SECTION 00 91 01

ADDENDUM NO. 1

BUILDINGS 5 & 6 RENOVATIONS
 San Mateo County Community College District

CAÑADA COLLEGE
 4200 Farm Hill Boulevard
 Redwood City, CA 94061

Drawing Number
A10.94R

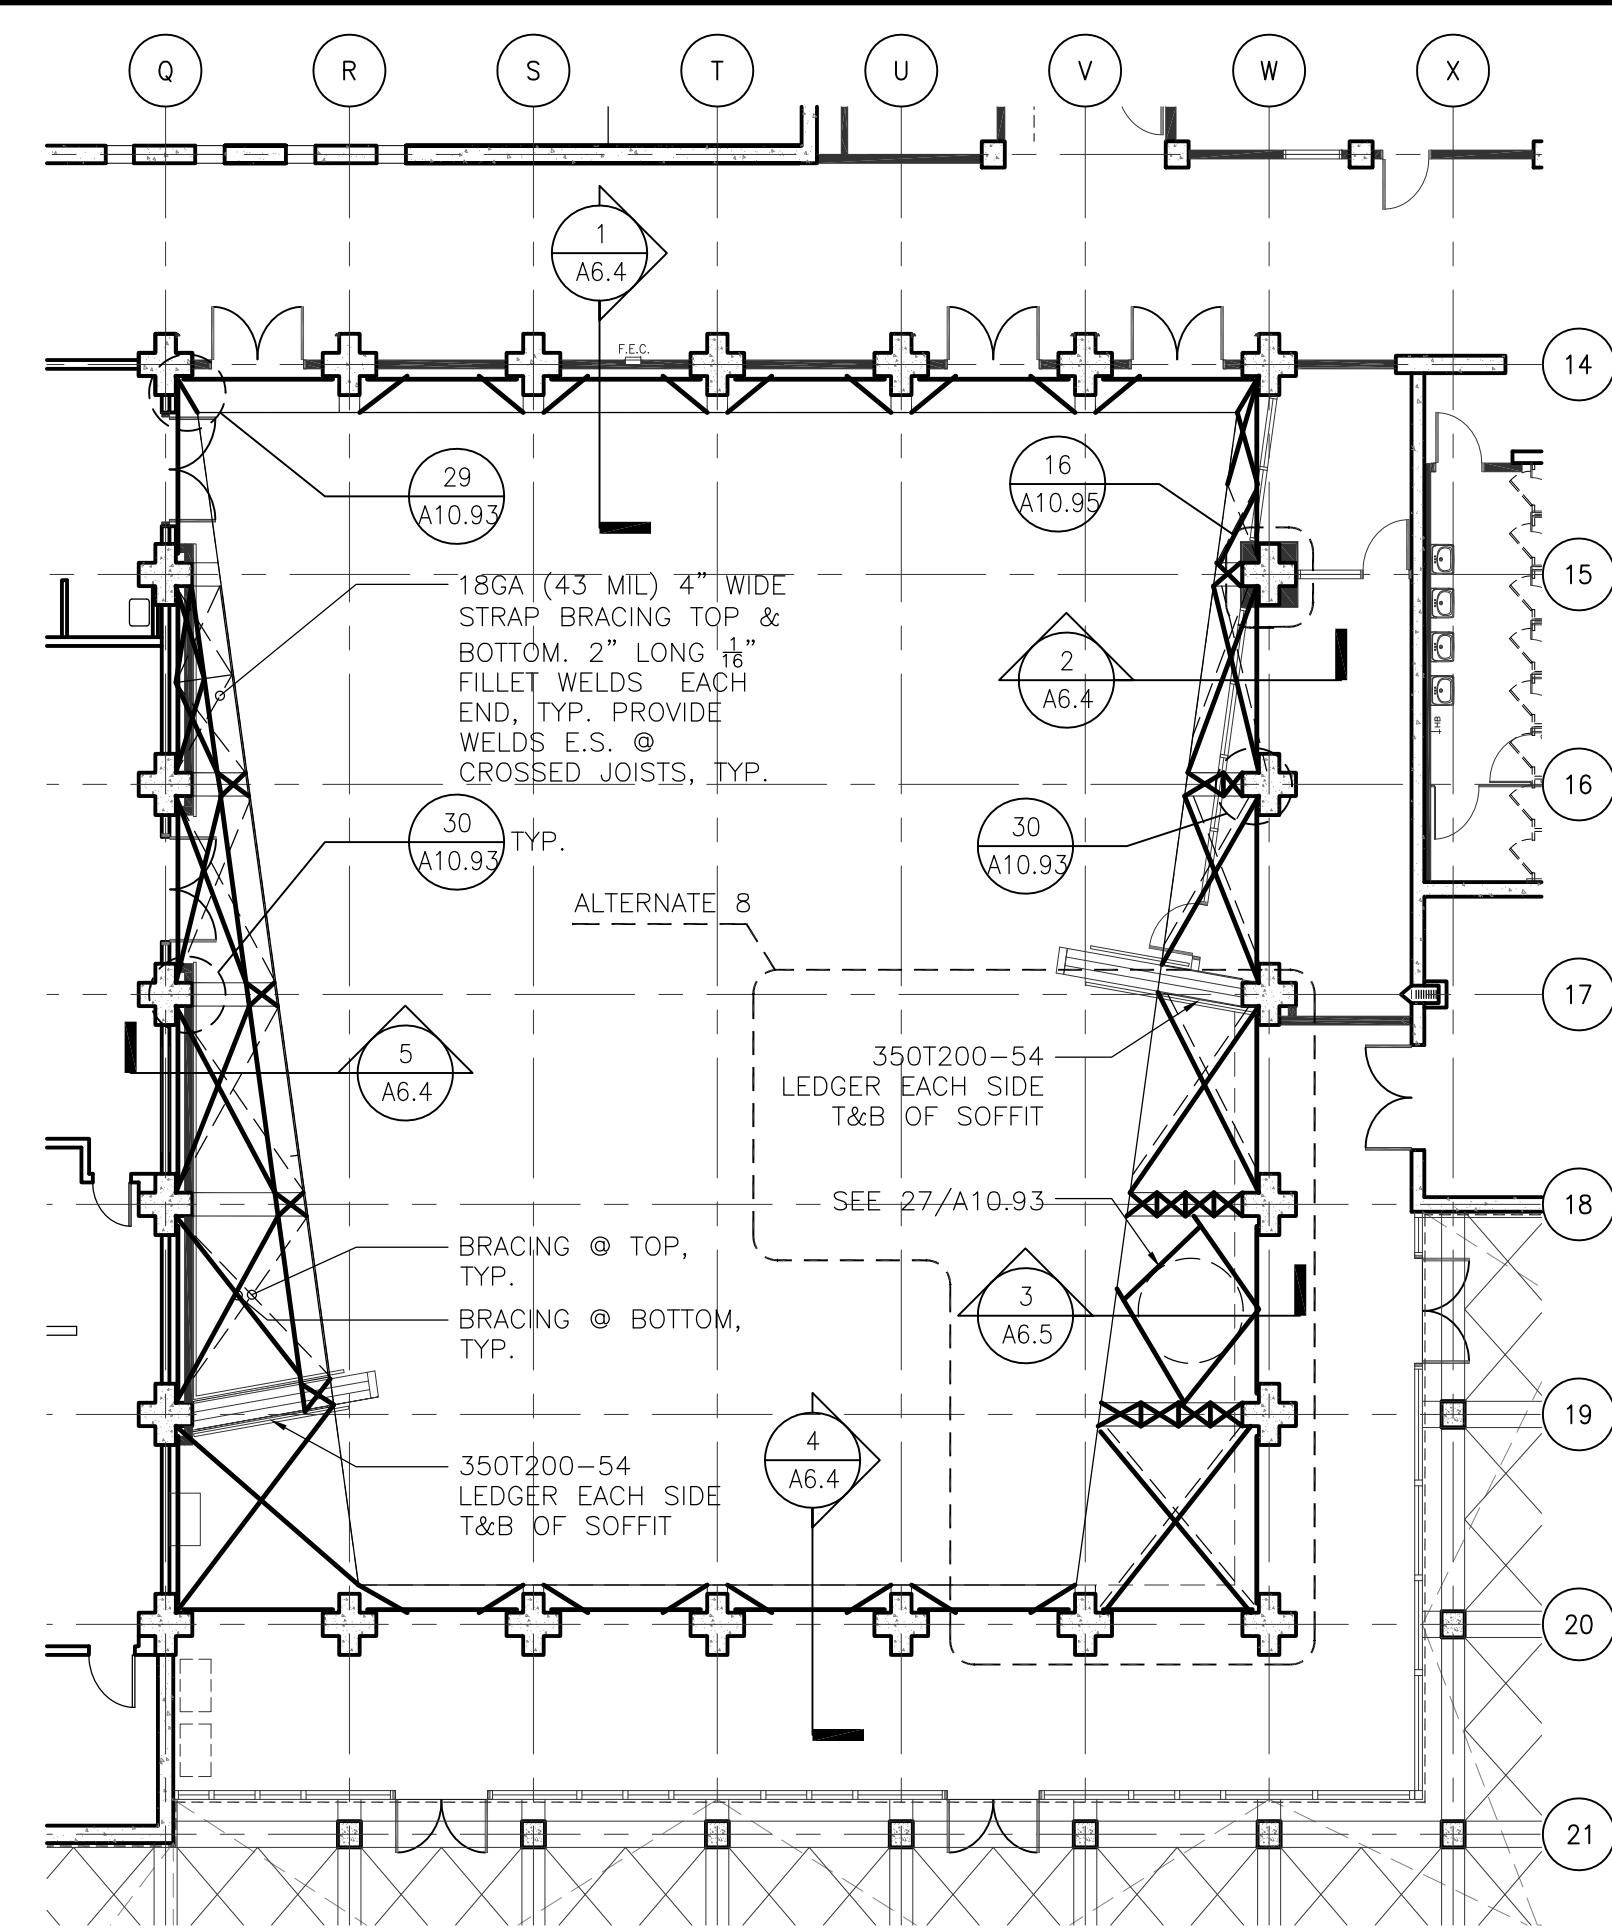
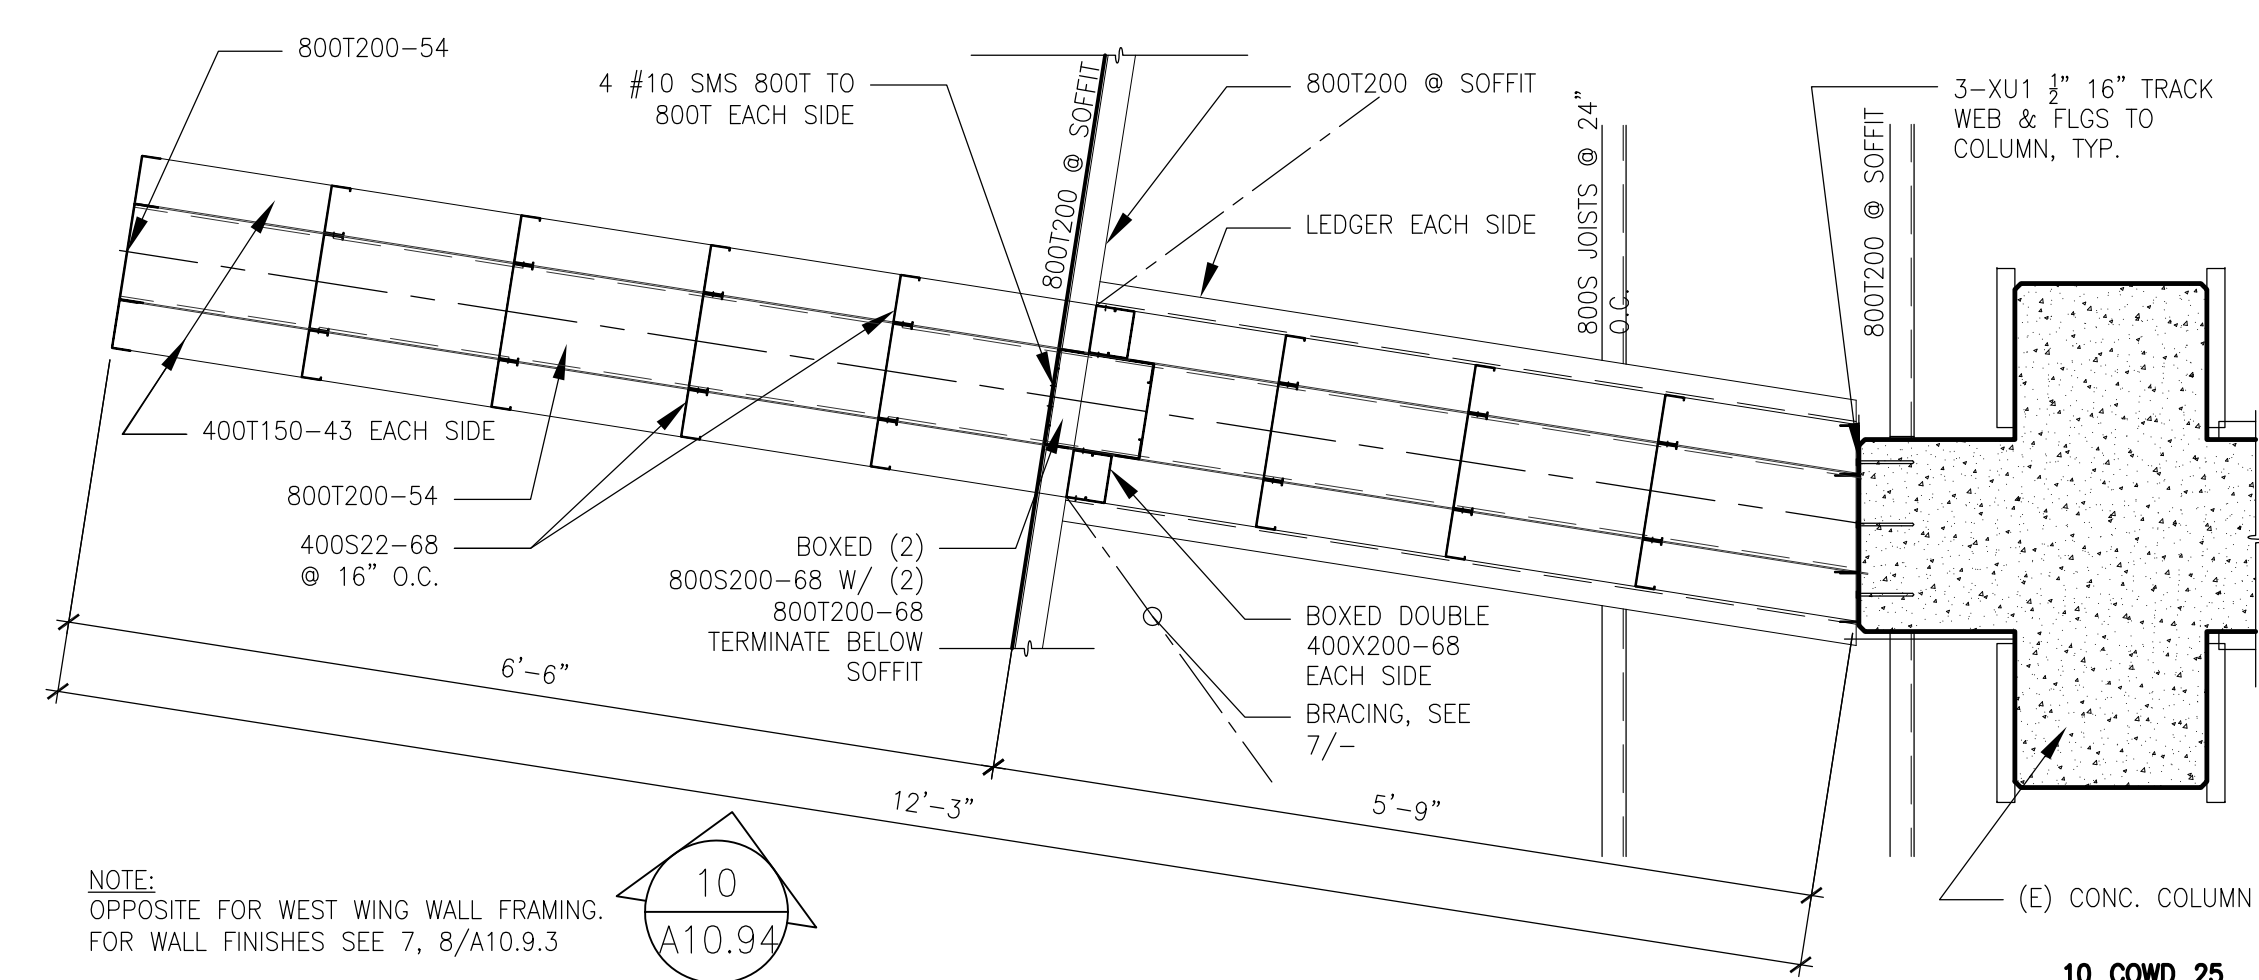
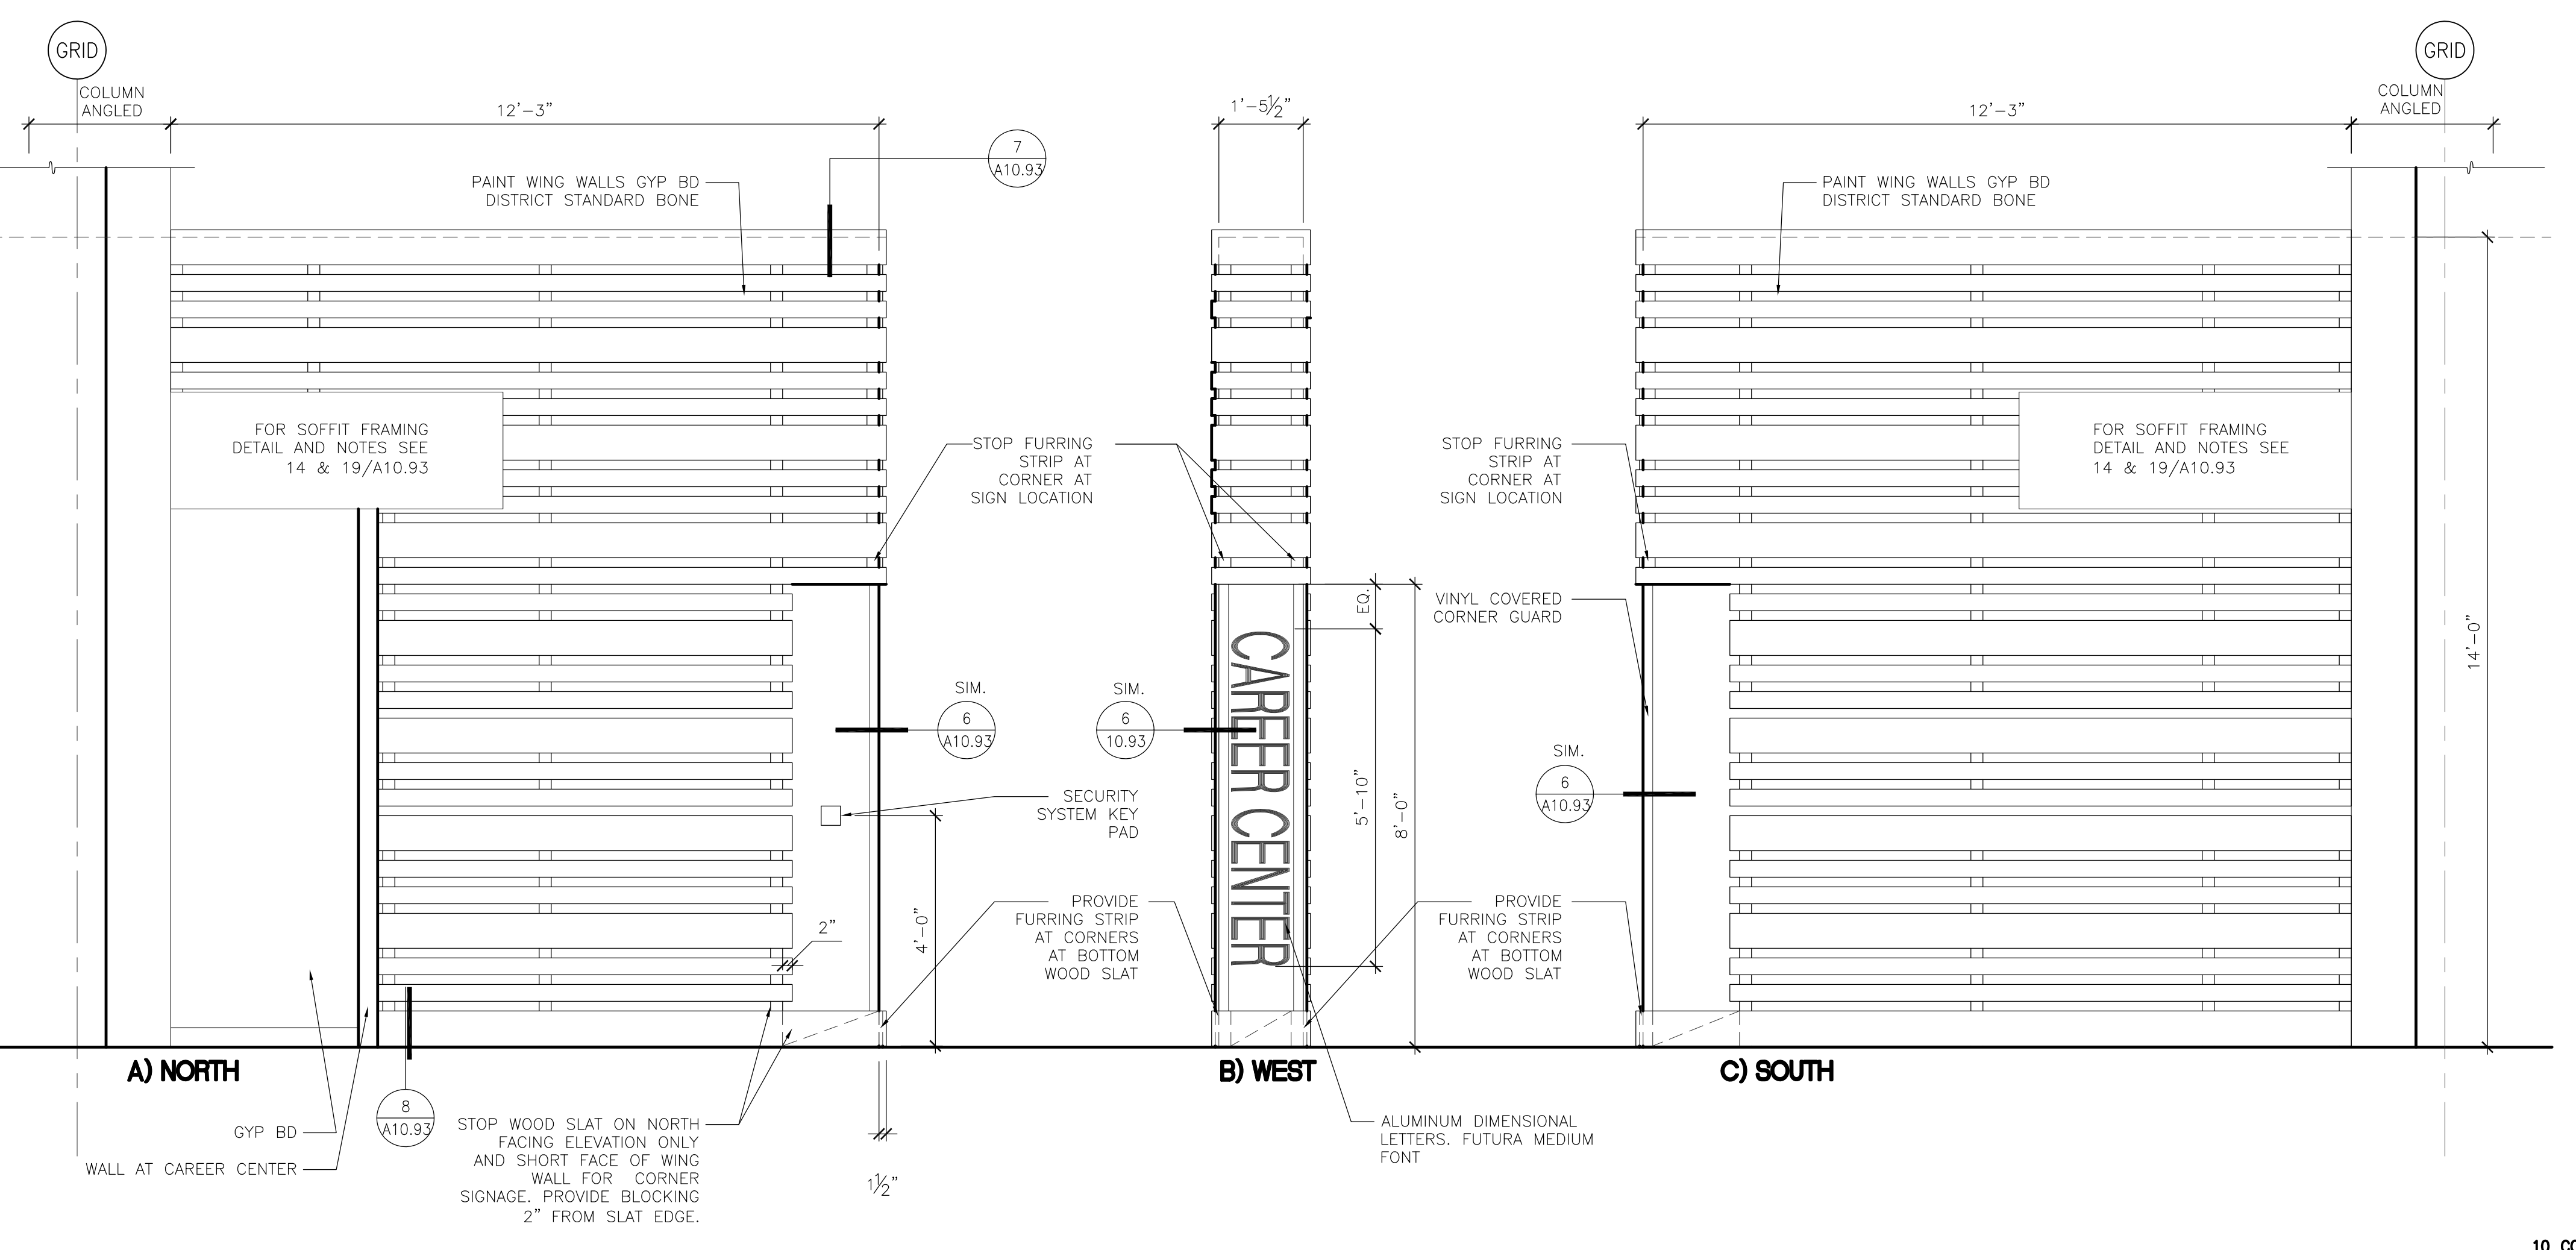
10. Drawing A10.94R – Wall Types and Casework Details
 - A. Revise Detail 30, as shown on attached Drawing A10.94R.
11. Drawing M2.3d – Mechanical Ductwork Plan – Third Floor.
